SCOTTS VALLEY GROUNDWATER MANAGEMENT PLAN (AB 3030)

**ADDENDUM TO
SCOTTS VALLEY
GROUNDWATER MANAGEMENT PLAN
(AB 3030)**

COMMENTS AND RESPONSES

October 1994

Figure 1
Study Areas

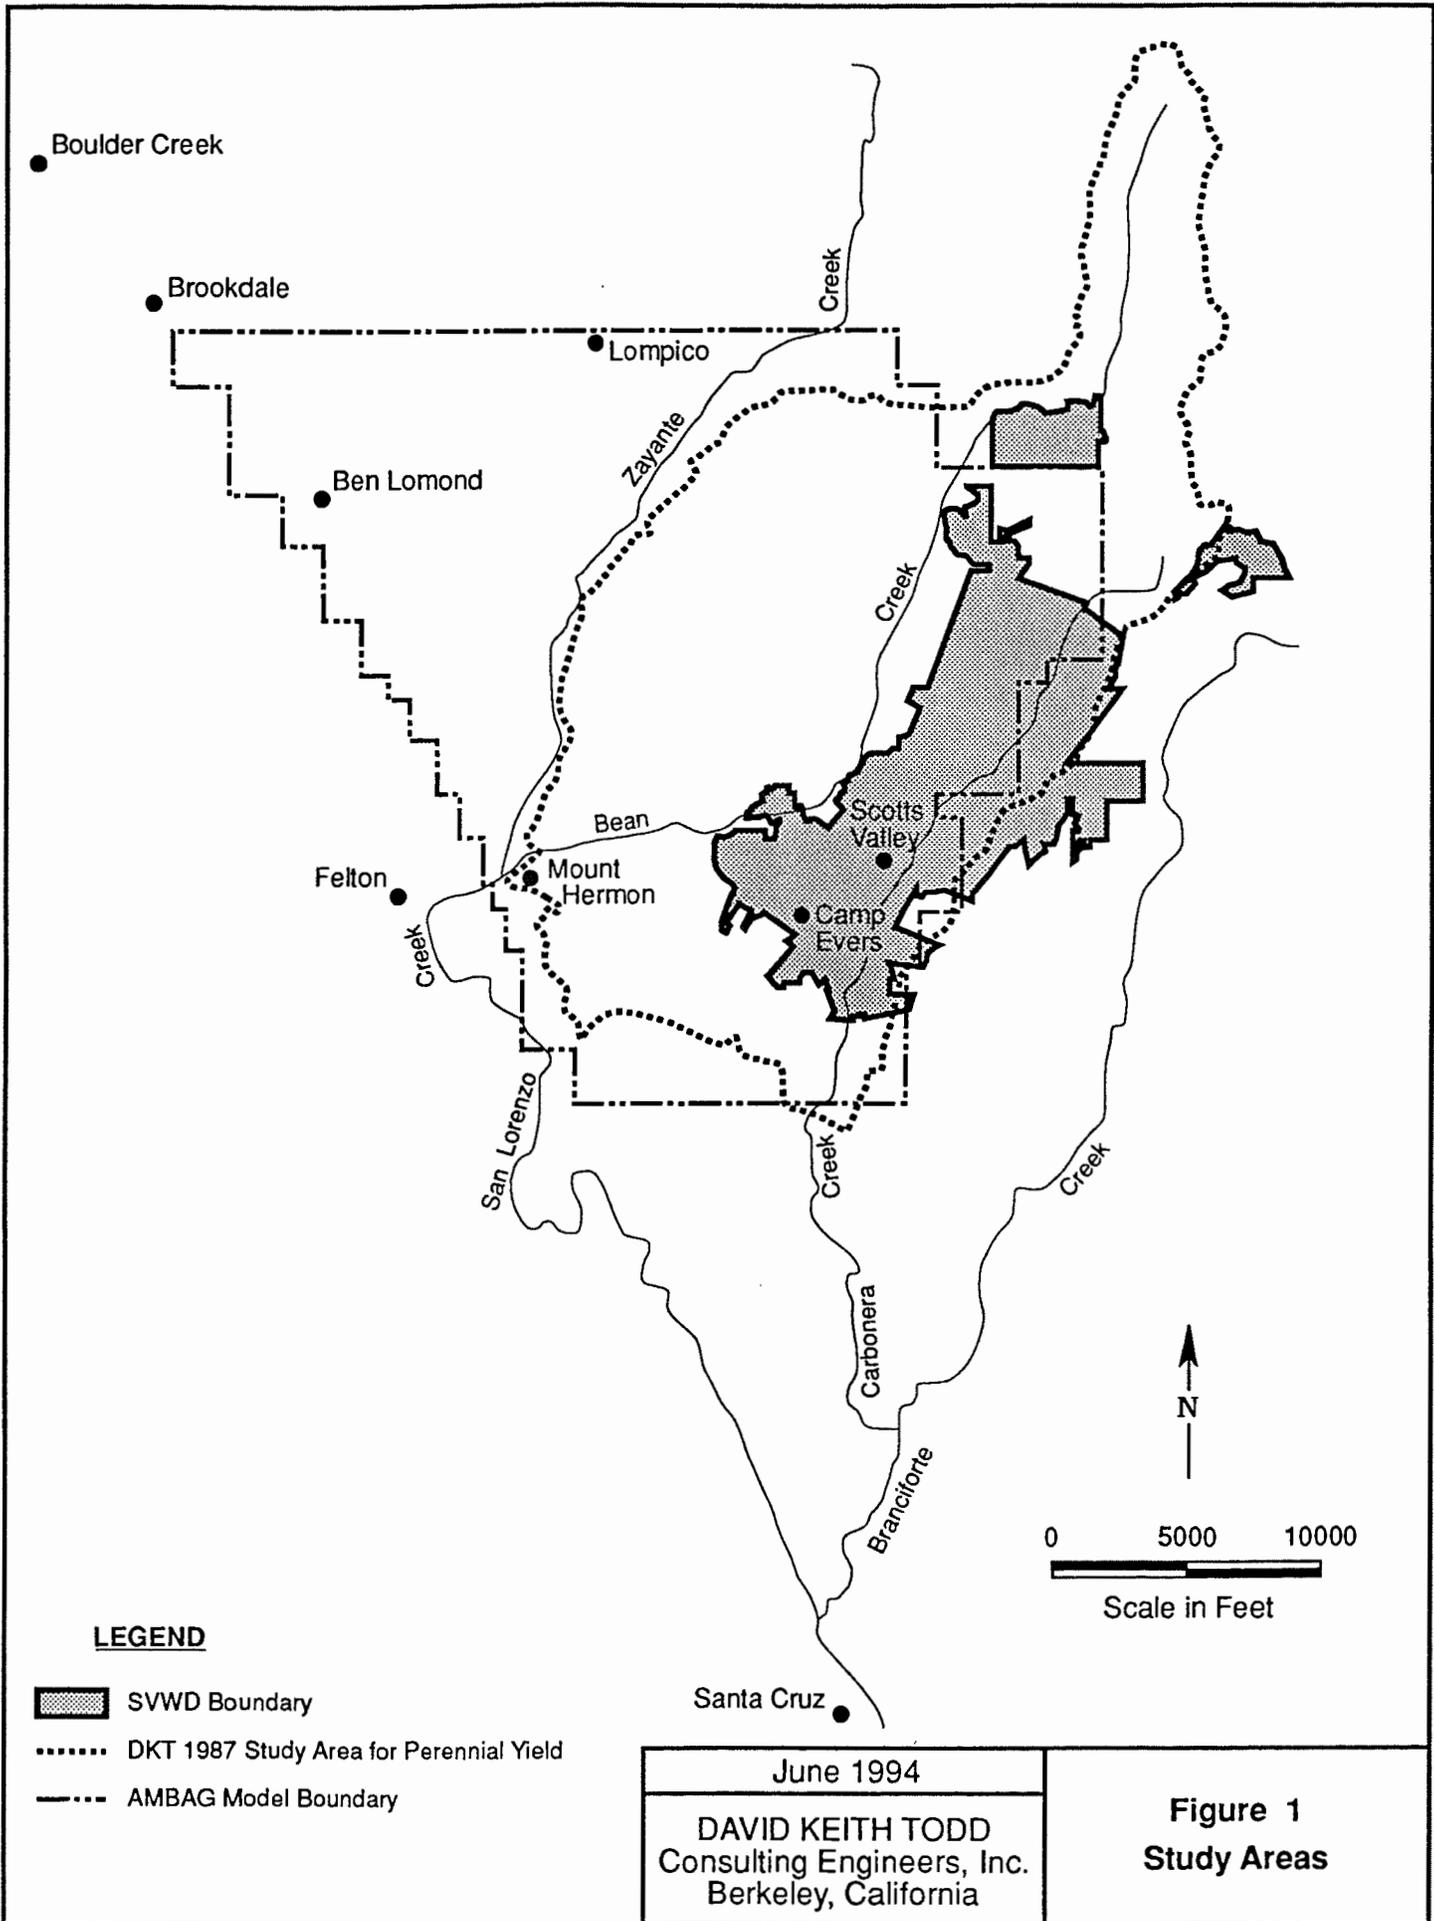
5. Page 17 also defines the perennial yield as the rate at which water can be withdrawn "without producing an undesired result." Please define "undesired result", and explain how it differs from "no reduction in stored capacity". A brief explanation of the methodology of the 1987 study resulting in the perennial yield figure of 4,200 AFY would also be appreciated.

6. On page 25 and again on page 30, including Table 3, reference is made to the "Scotts Valley Groundwater Basin". Please clarify this term, relative to the SVWD boundaries, Santa Margarita basin, AMBAG model boundary, etc. Page 30 attempts to define this by reference to Figure 1, but there are many boundaries shown on that map.

The 1987 perennial yield figure of 4,200 AFY was evaluated for the area within the dotted line on Figure 1. Briefly, it was calculated initially as the product of geologic outcrop areas and an estimated recharge rate for each geologic formation, calibrated with similar conditions in the adjacent Branciforte Basin. The perennial yield value subsequently was revised to the currently-used value of 4,200 AFY in light of updated hydrogeologic information and computer modeling.

A: The Scotts Valley groundwater basin, as described in reports by Todd Engineers and referred to on pages 25 and 30, is the area indicated on Figure 1 as the "DKT 1987 Study Area for Perennial Yield".

Figure 4
Cross Section
A - A'

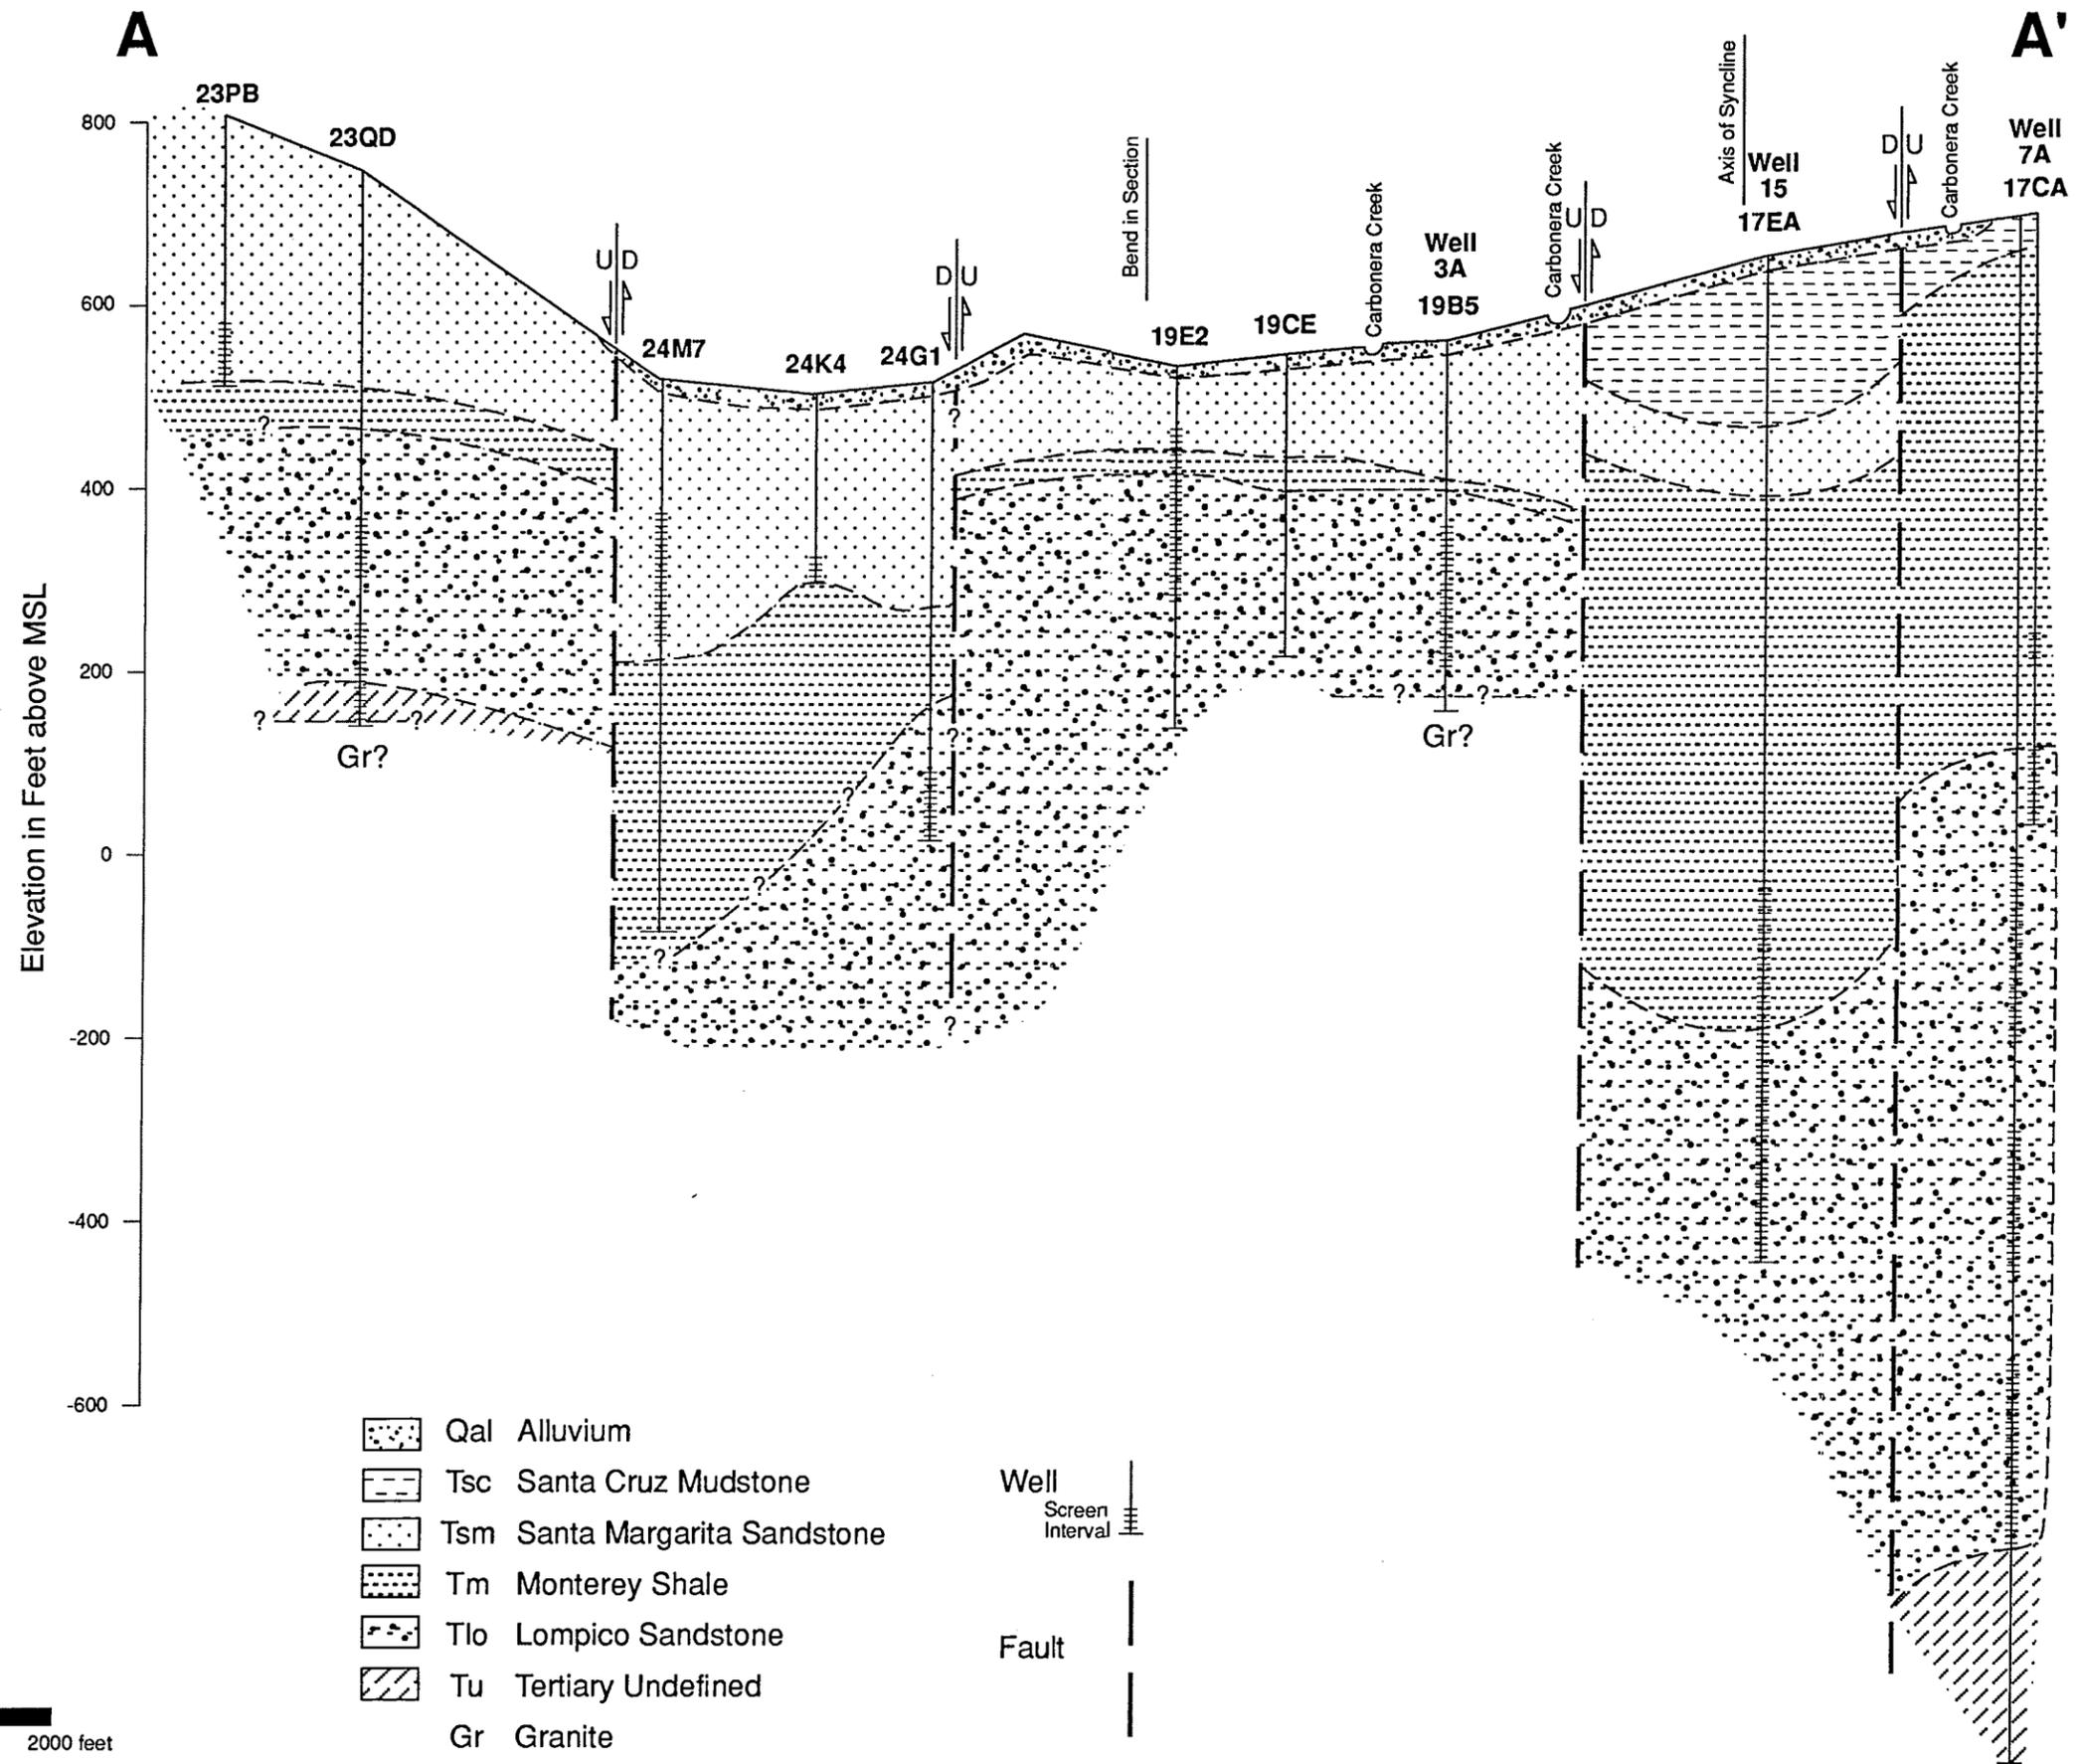
1. Figure 4... Some of the directional arrows on the indicated faults are transposed.

Figure 7
Water Level Change
April 1986 - April 1993

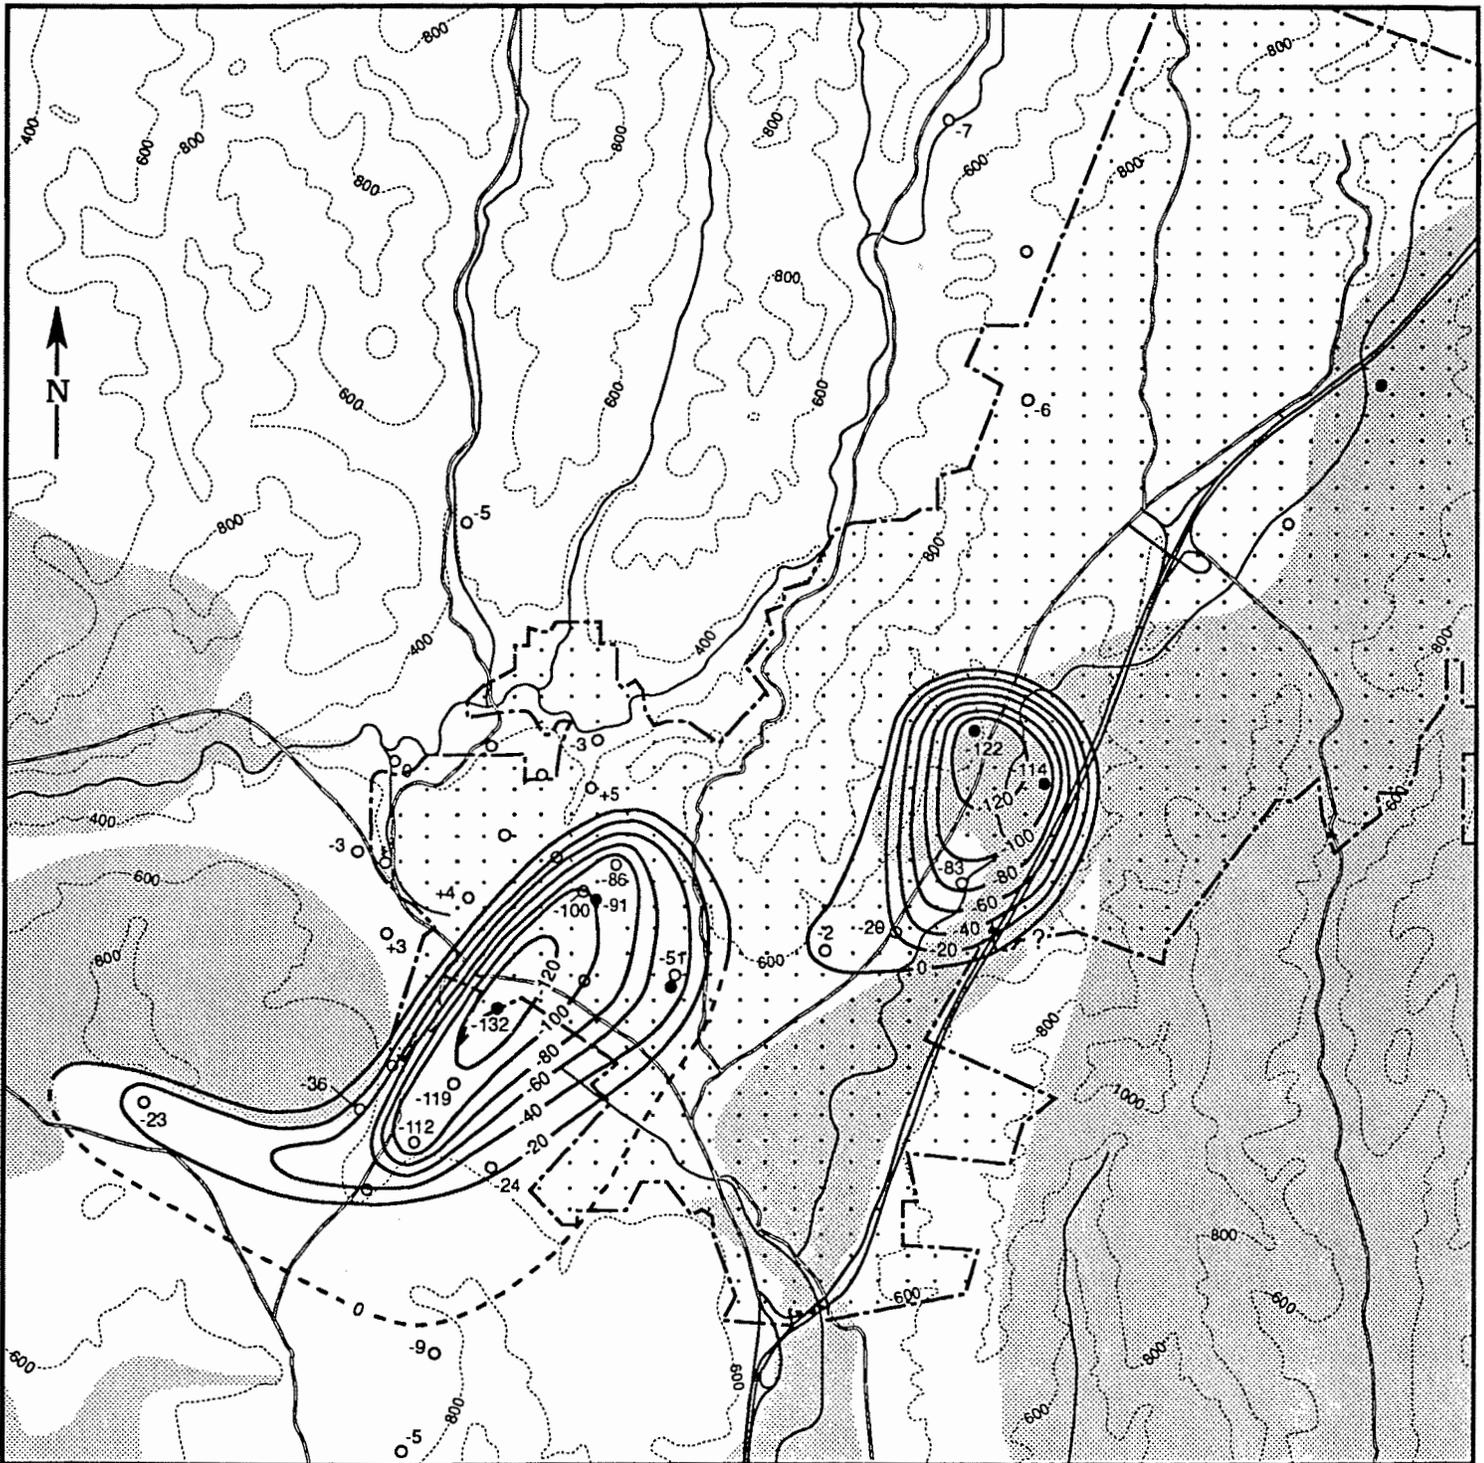
4. Figure 7... Staff suggests evaluating the need to add shading to the Camp Evers pumping depression and Mt. Hermon/Probation area if the Santa Margarita formation has been locally dried up.

A: Comment noted. Also note in Figure 7, Water Level Change, that changes in water levels have been relatively stable in the Watkins-Johnson/Skypark area between Bean Creek and the area of groundwater level declines in Camp Evers.

Figure 15
Underground Storage Tank and Hazardous Material Locations

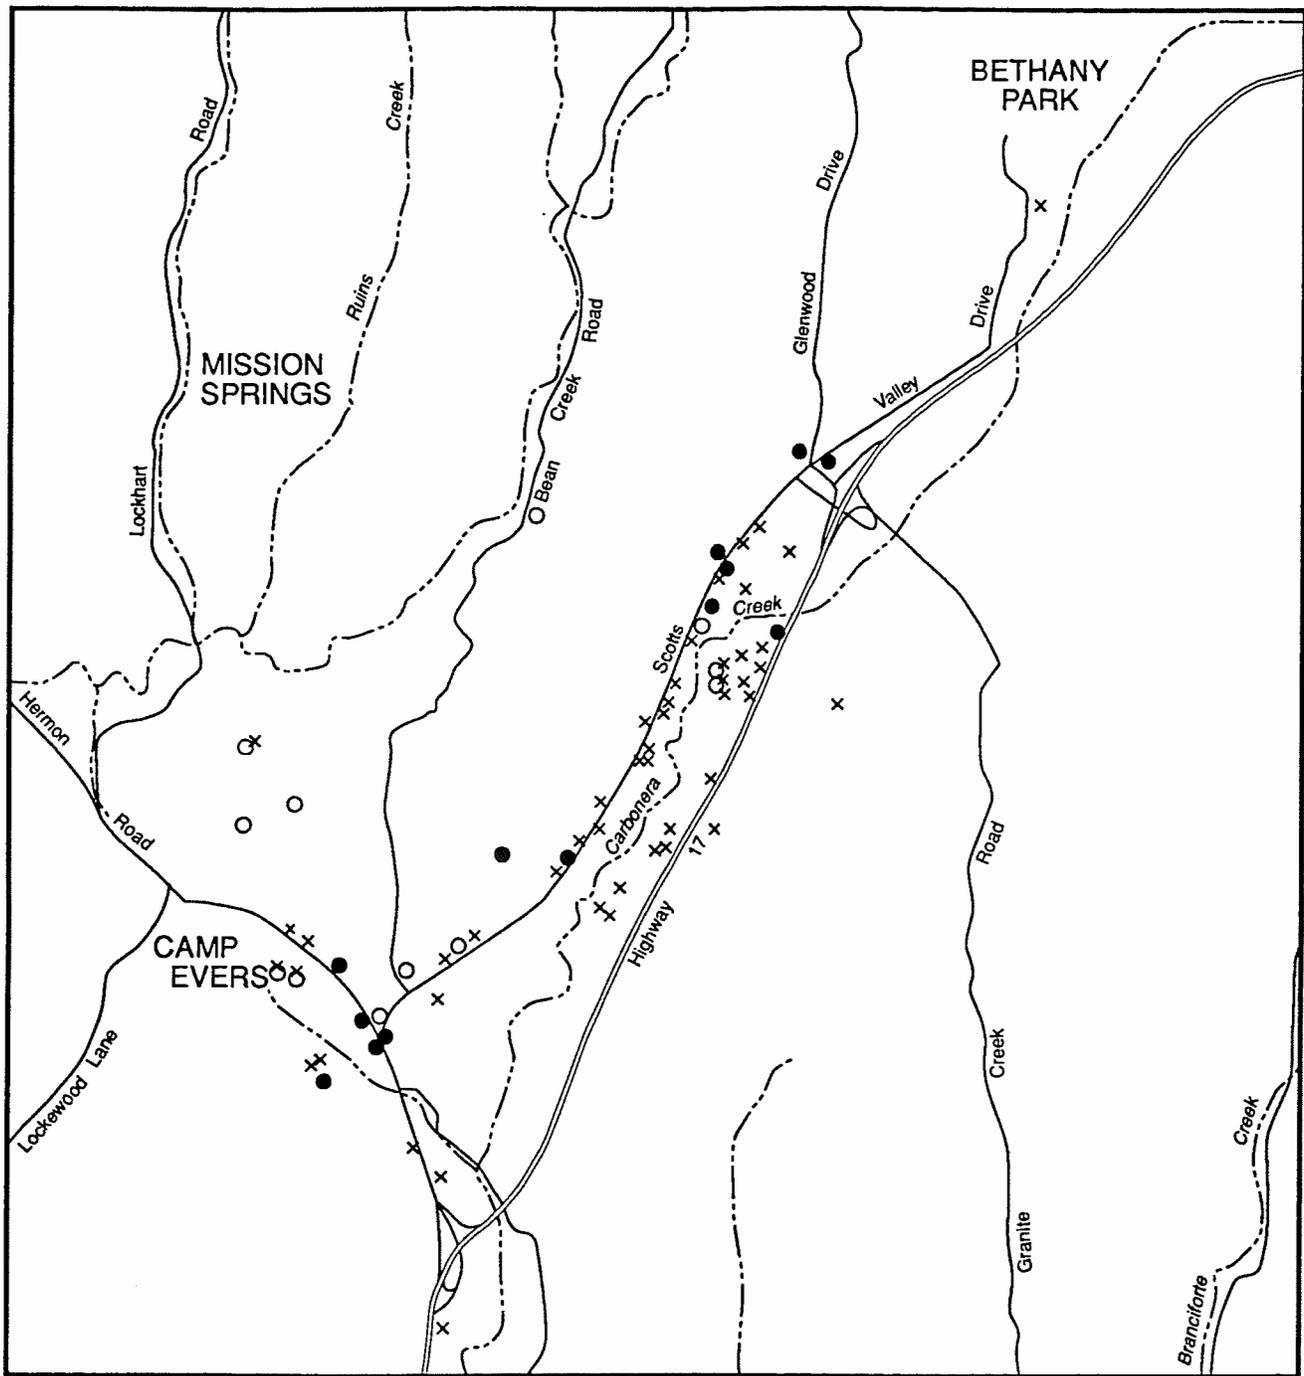
14. Figure 15 indicates a hazardous material user near the Bethany site and another to the east of Hwy 17 in the Navarra residential neighborhood. Please clarify the locations and materials used at these sites.
